Plan Commission

Agenda

Monday, April 22, 2019

6. Recommendation regarding a Site Plan for a new building and parking garage called De Pere Brick Yard at 1091 N. Broadway Street (Parcel ED-1128-E-1-3). Submitted by Dave Hongisto, SISU Properties LLC, authorized representative for Nulund Group II LLC, property owner.

C5.1

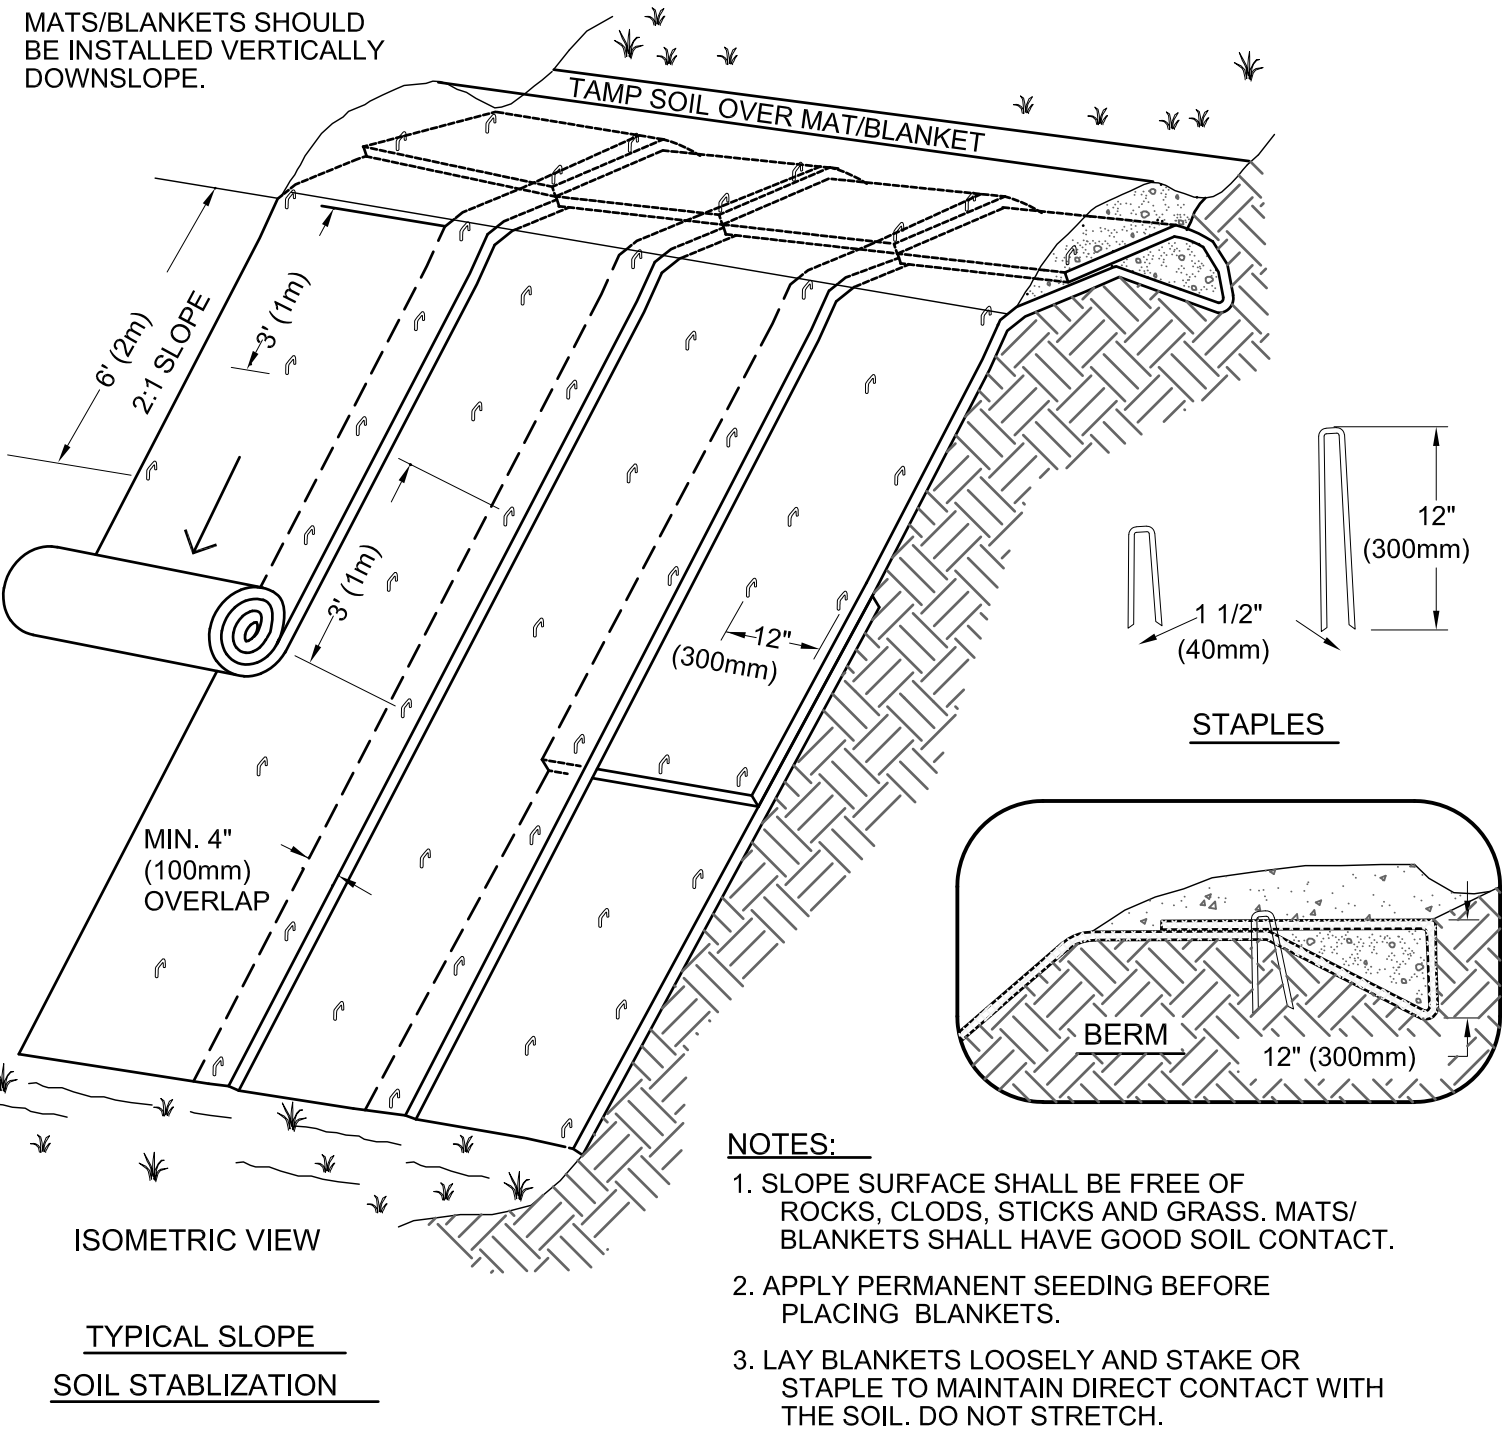
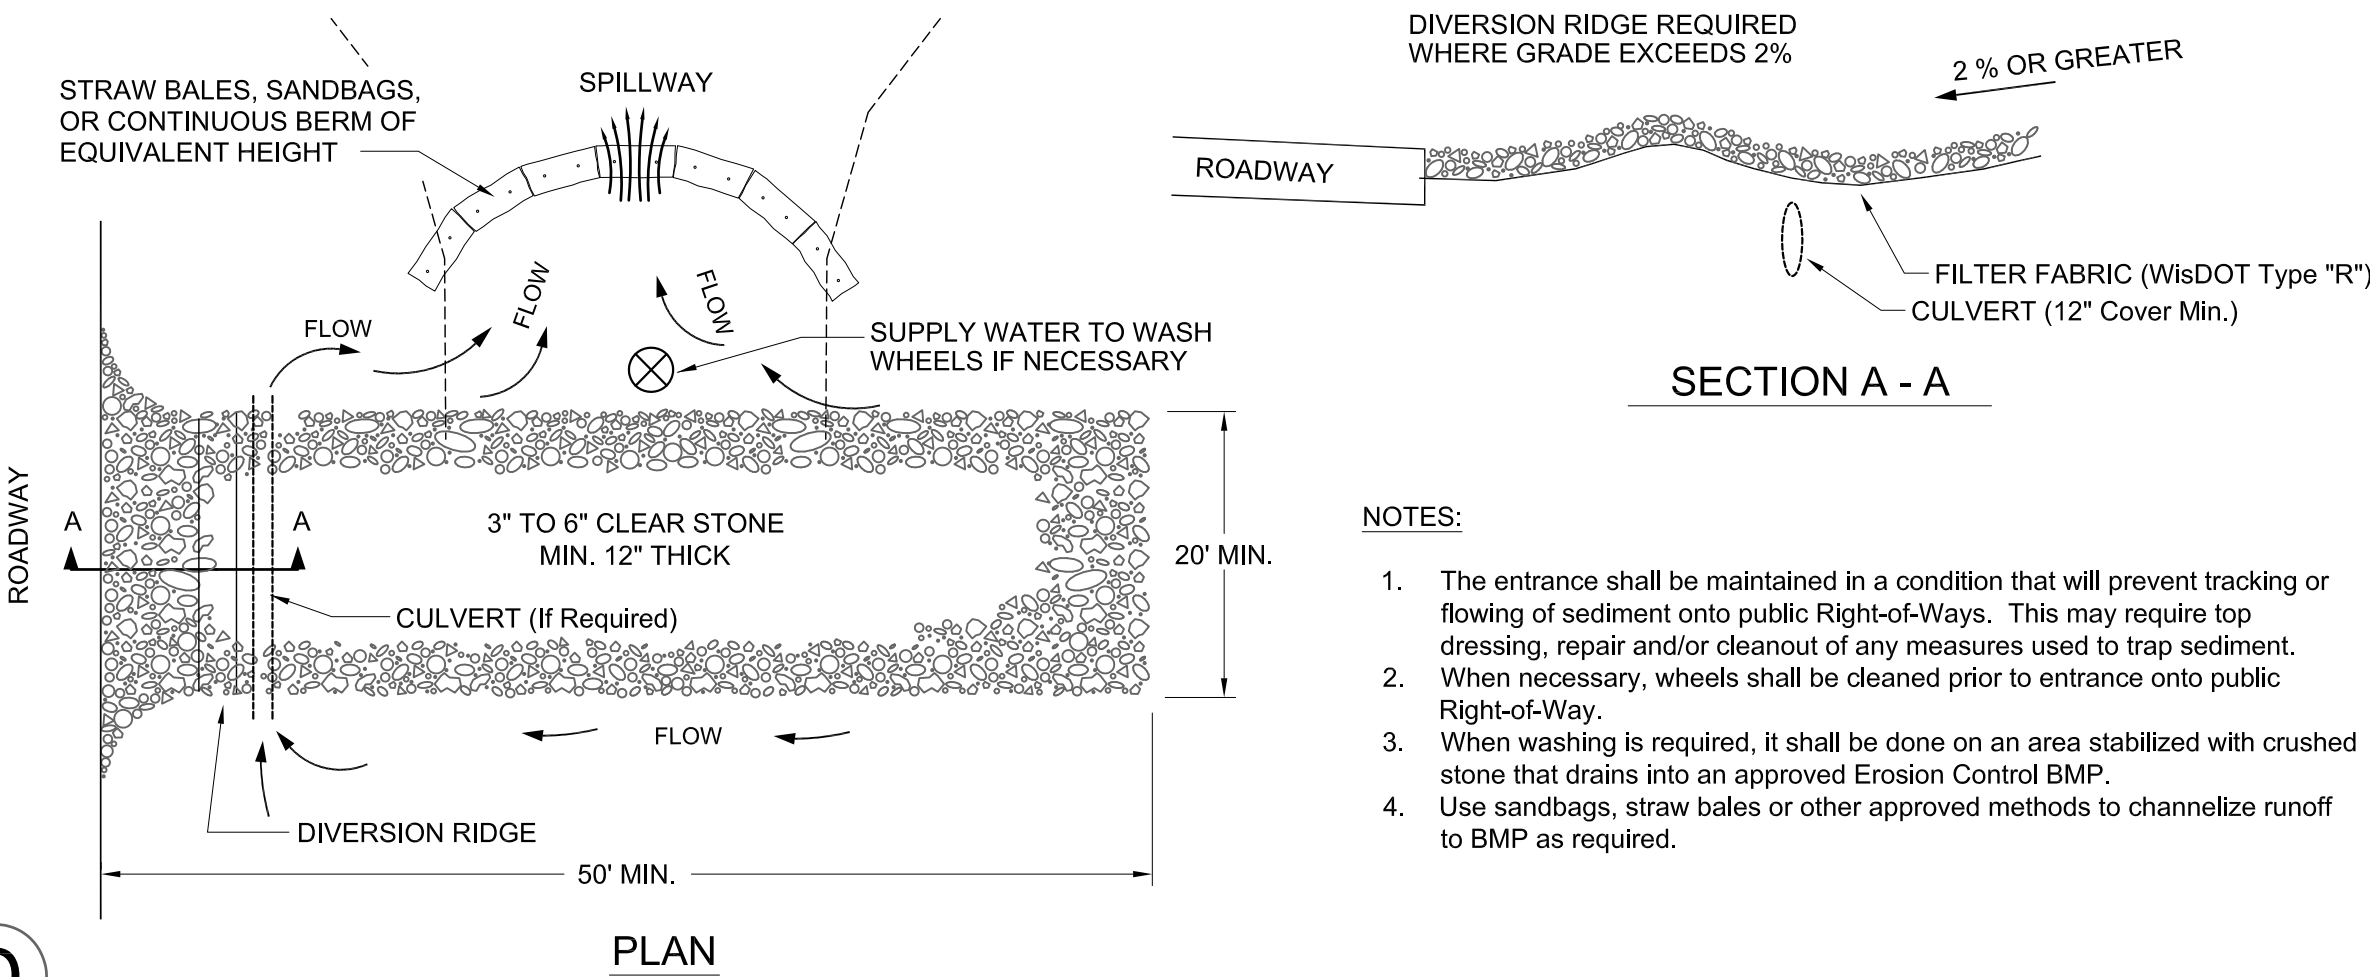
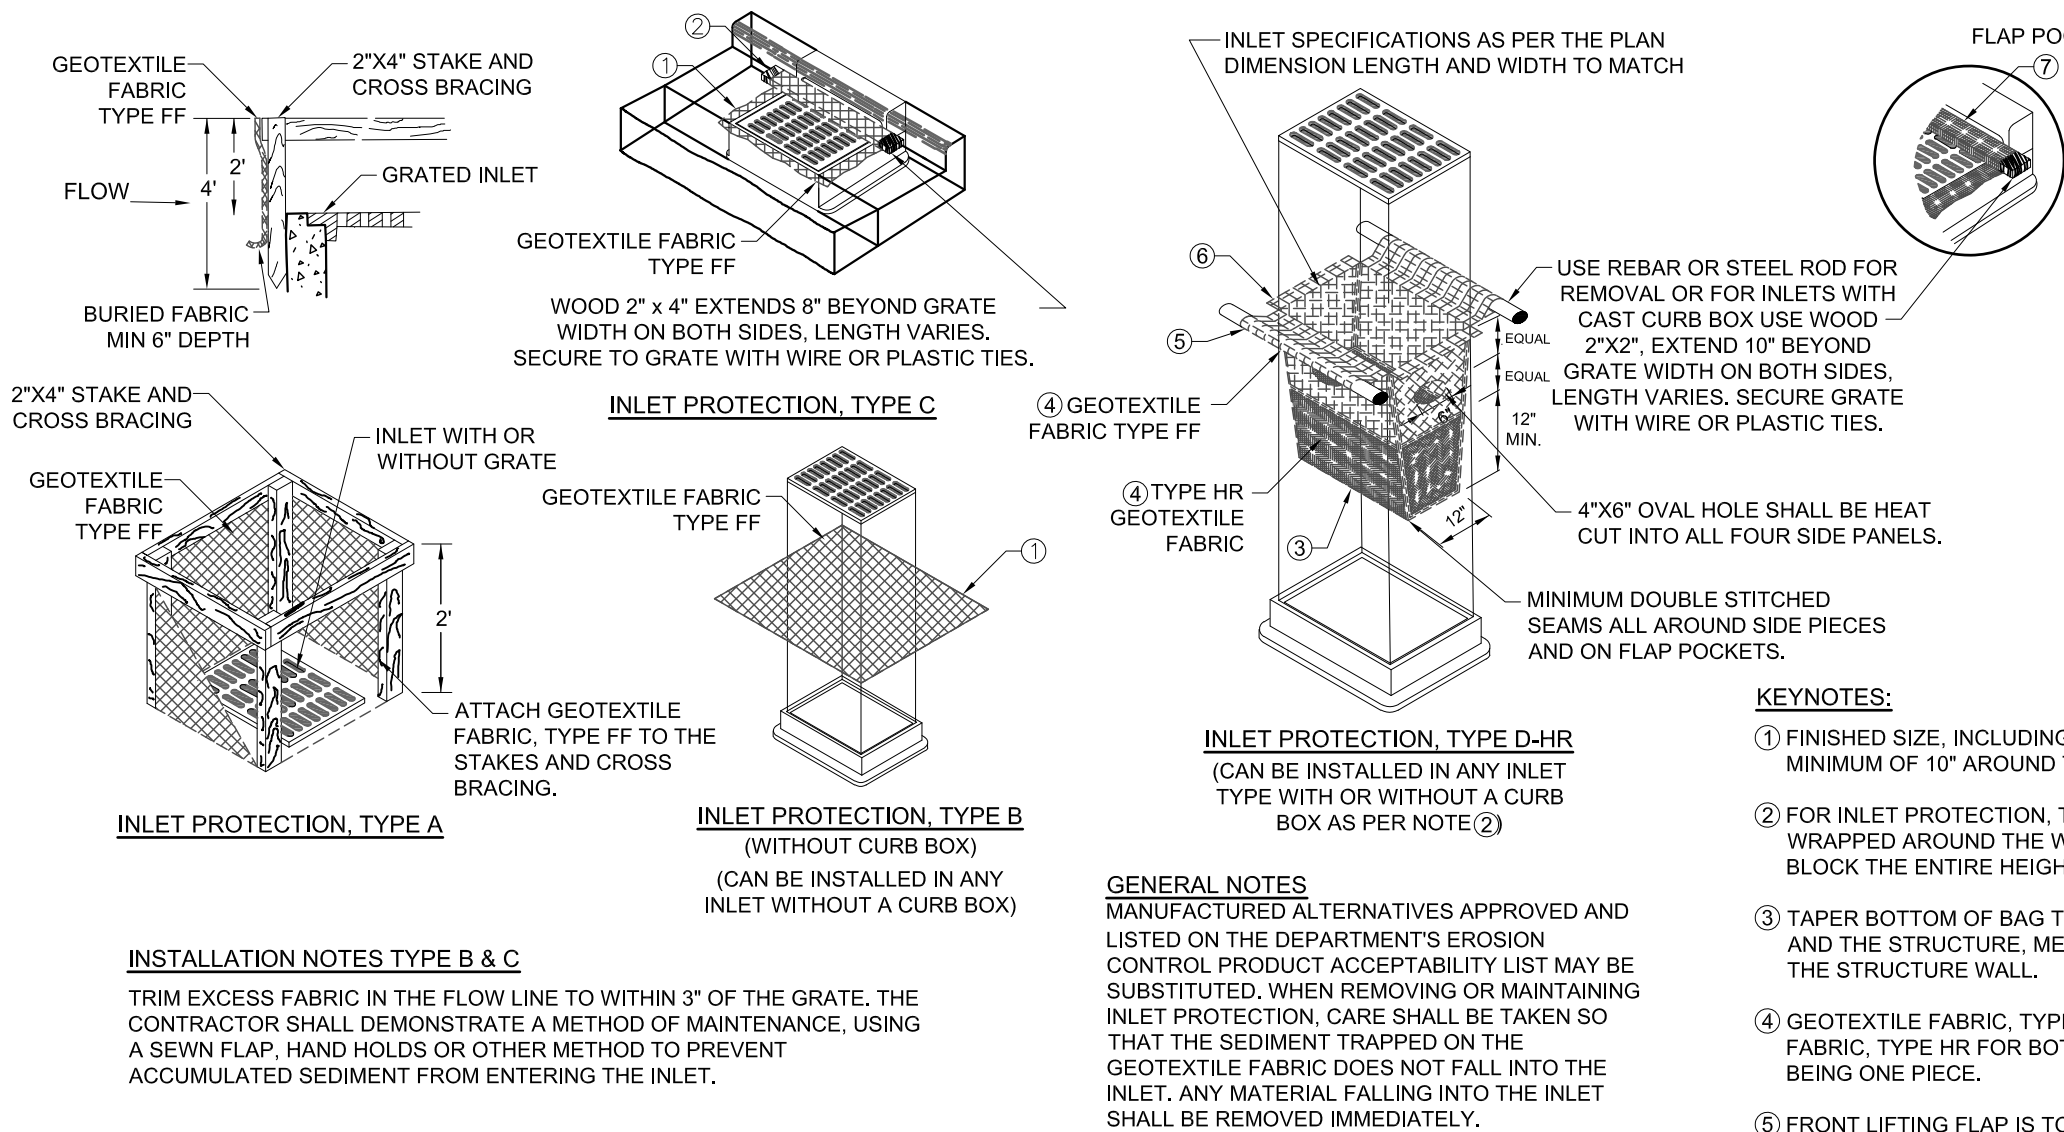
13. Sheet C5.0 - Need to show material stockpiling locations with erosion control protection.
14. Sheet C6.0 - Detail B Comment 3: Sidewalk width is 5.0 feet per City standards. As referenced on sheet C2.0.
